# United States Patent and Trademark Office

APPLICATION NO.	FILING DATE	FIRST NAMED INVENTOR	ATTORNEY DOCKET NO.	CONFIRMATION NO.
10/625,975	07/24/2003	John E. Hakala	1072-106.US	1695
7	590 06/13/2006		EXAMINER	
Colin P. Abrahams			KIM, CHRISTOPHER S	
Suite 400 5850 Canoga Avenue			ART UNIT	PAPER NUMBER
Woodland Hill			3752	
DATE MAIL		DATE MAILED: 06/13/200	6	
	f

### **DETAILED ACTION**

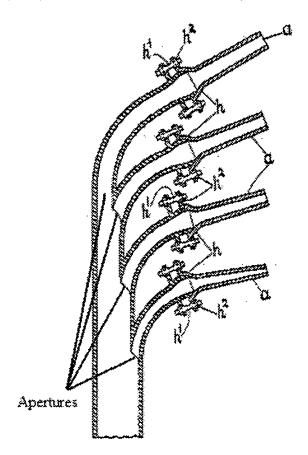
5. Claims 23-28 are rejected under 35 U.S.C. 102(b) as being anticipated by Pougnet (1,102,354).

Pougnet discloses a nozzle comprising: a wall b defining a water cannel; a water deflector **a**; a further deflector (vanes of pipe **b**) associated with the middle aperture and a deflector (vanes of pipe **b**) associated with the lower aperture. See figure below.

Applicant argues that Pougnet does not discharge water from the apertures in the wall but rather from nozzles in the form of extension pipes projecting outwardly from the all of the vertical pipe b. Applicant's argument is not commensurate in scope with the claimed invention. Claim 23 does not preclude the nozzles a of Pougnet.
